HISTORIC AND DESIGN REVIEW COMMISSION

HDRC CASE NO: 2017-636
ADDRESS: 423 N HACKBERRY ST
LEGAL DESCRIPTION: NCB 576 BLK 15A LOT N 30.32 FT OF 12
ZONING: RM-4 H
CITY COUNCIL DIST.: 2
DISTRICT: Dignowity Hill Historic District
APPLICANT: John Brearley
OWNER: John Brearley
TYPE OF WORK: Construction of a 2-story single family home
APPLICATION RECEIVED: December 01, 2017
60-DAY REVIEW: January 30, 2018
REQUEST:

The applicant is requesting a Certificate of Appropriateness for approval to construct a 2-story single family home on the vacant lot at 423 N Hackberry.

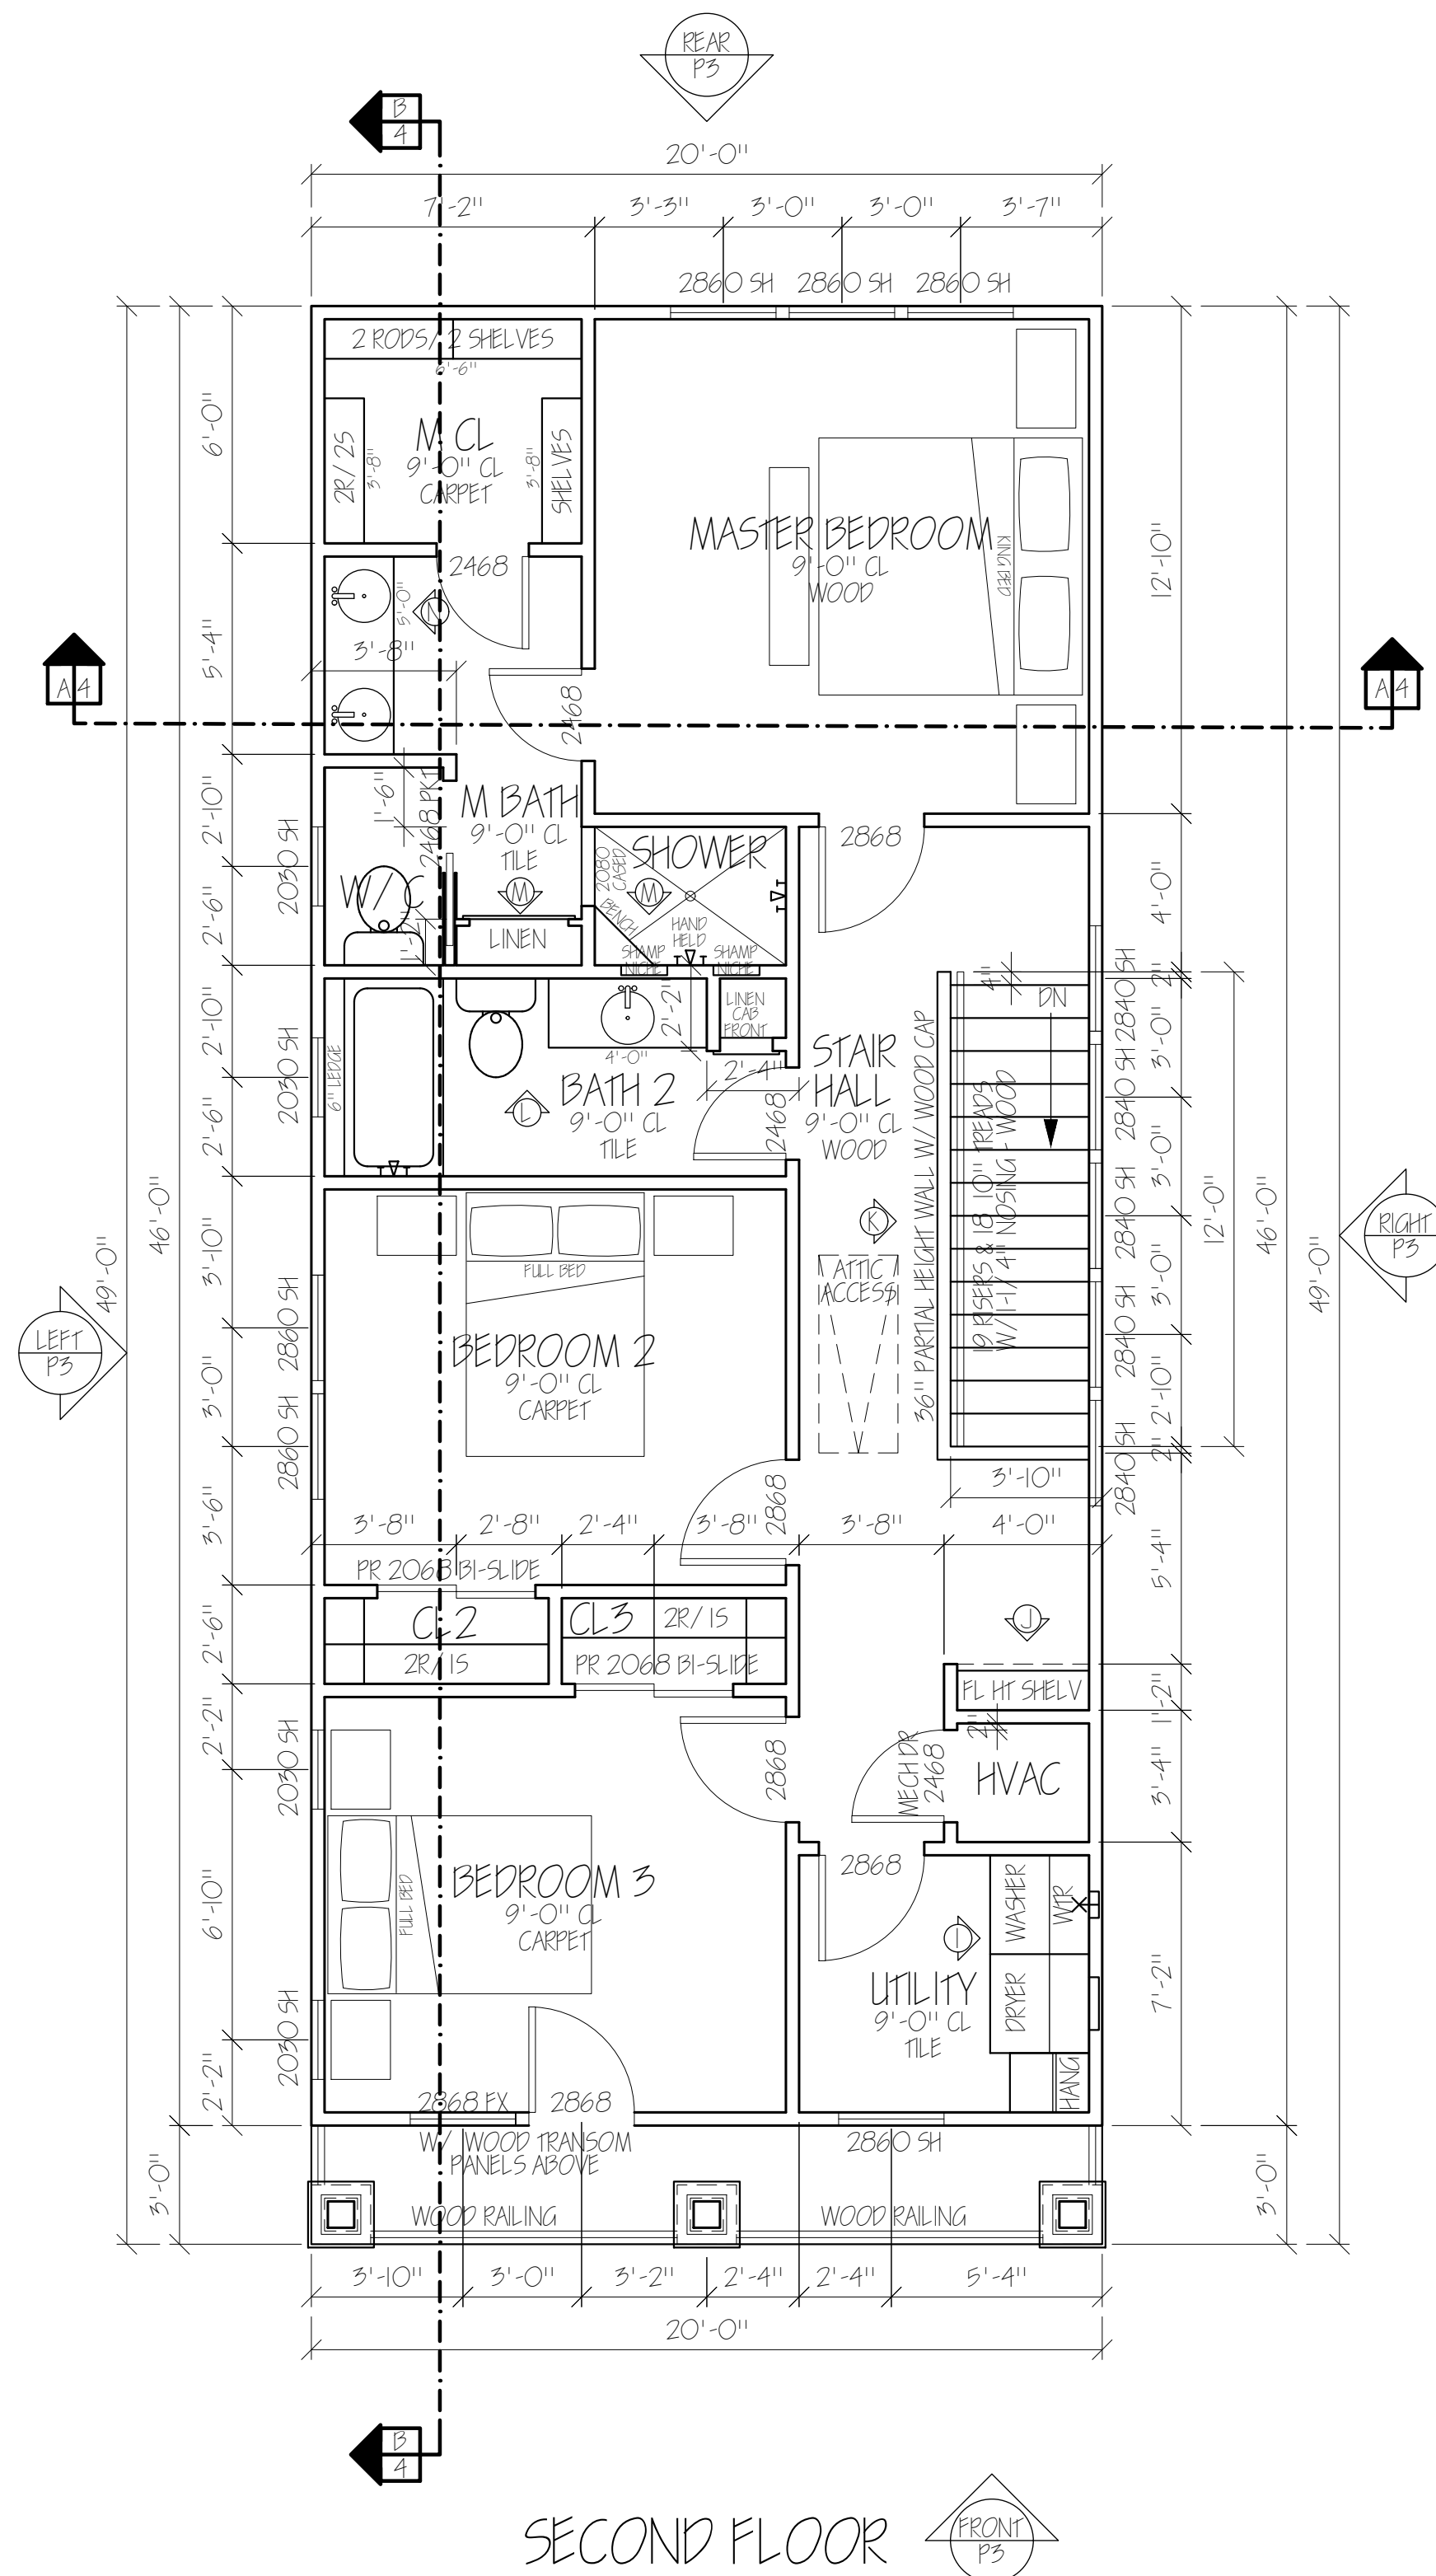
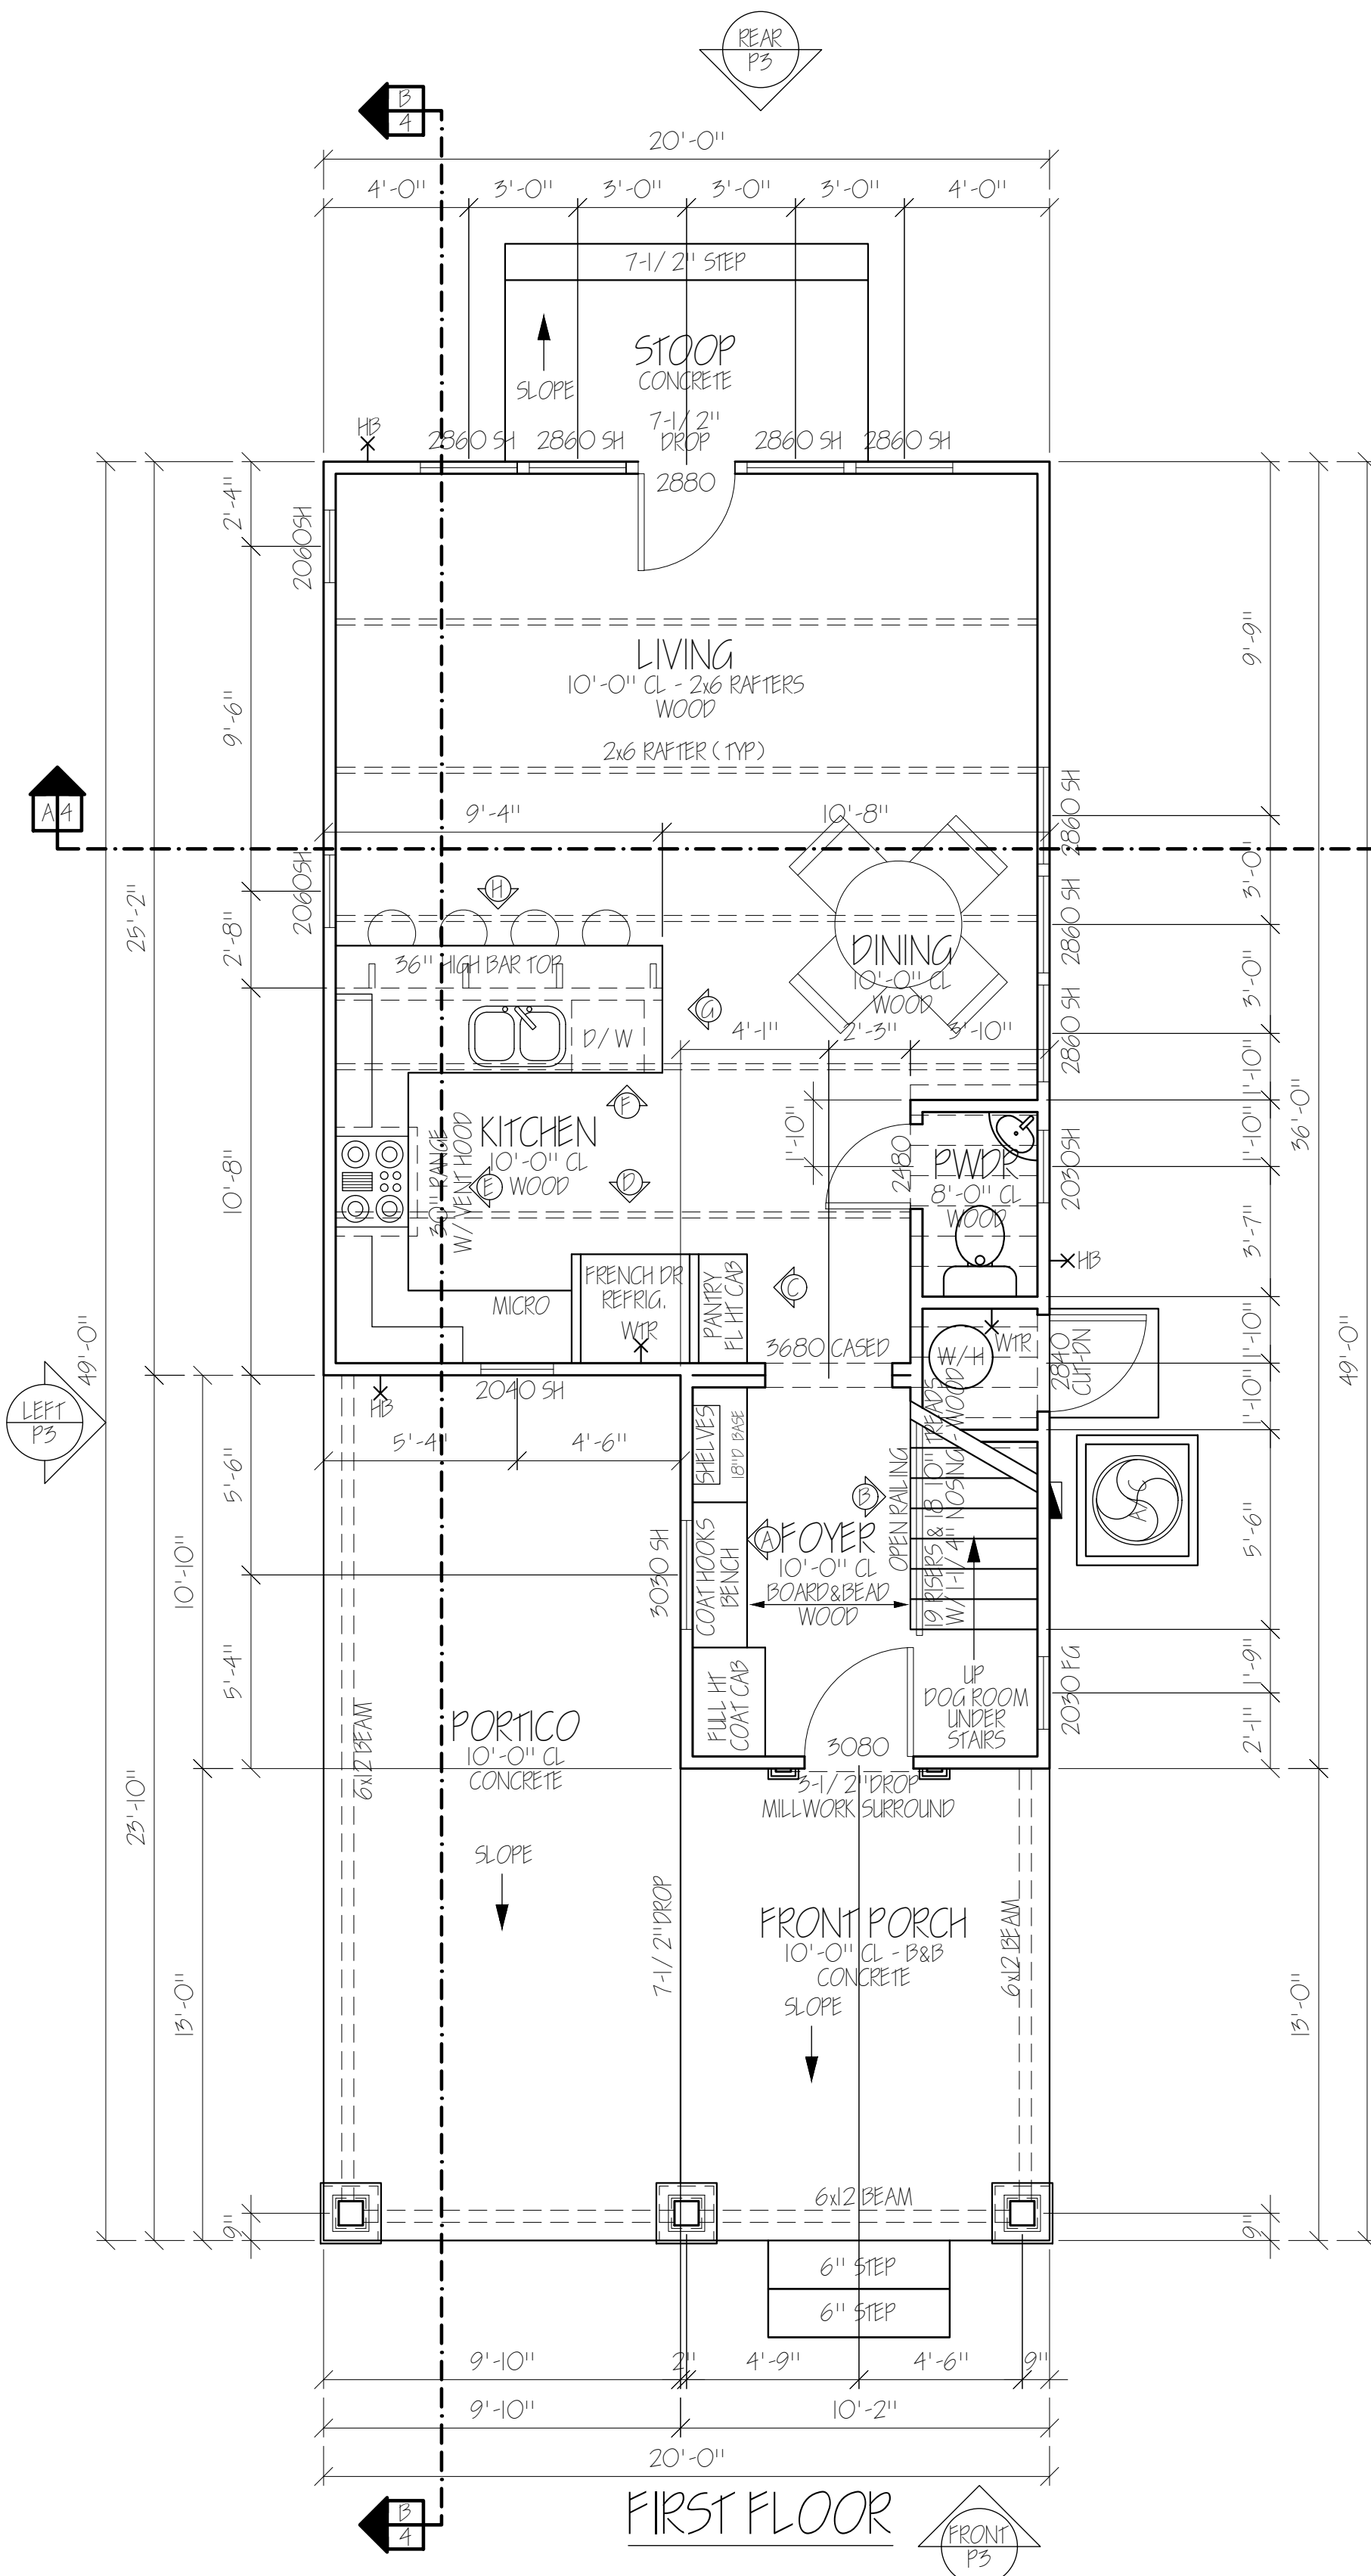
RHYTHM IS MIXED. TYPICALLY, EXISTING HOUSES ARE
18-24 INCHES OFF GRADE. Like to see elevated floor
level. Slab on grade is an issue, but then extends
ridge line. Porch could be taller. Variance for parking
may not apply.

Projecting porch effectively "closed" - maybe close it.
Would look like an existing pattern. →

Alien to pattern - parking car within porch.

Enclosing porch: more projection, more opportunity for fenestration.

Parking could be filled as a porch - hypothetically.

- i. That the applicant proposes an alternative solution for the driveway and parking configuration that responds to the predominant historic development pattern in the district and maintains a traditional porch form instead of the proposed covered parking.
